March 6, 2023

## Product Change Notice - Connector added to 40" and 24" actuators

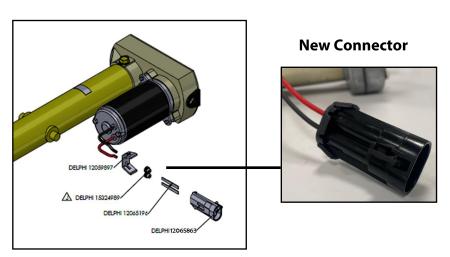
Please be advised, to improve product performance, Lippert is adding a waterproof connector to our through-frame slide-out actuators 40" (PN 168596) and 24" (PN 119128).

Currently, the actuators are shipped with loose wires and the customer attaches their choice of connector, usually crimped-on spade wire connectors.

The new actuator connector is a component currently being used on other Lippert-provided motors. The new connector prevents corrosion in the contacts/wiring and improves serviceability of the actuator.

With the addition of the connector, customers will need to add a mating connector to their wiring harness. The mating connector components below can be purchased from APTIV: <a href="https://www.aptiv.com/en">https://www.aptiv.com/en</a>. Lippert representatives will also be providing information to customers on other wholesalers where the parts can be purchased.
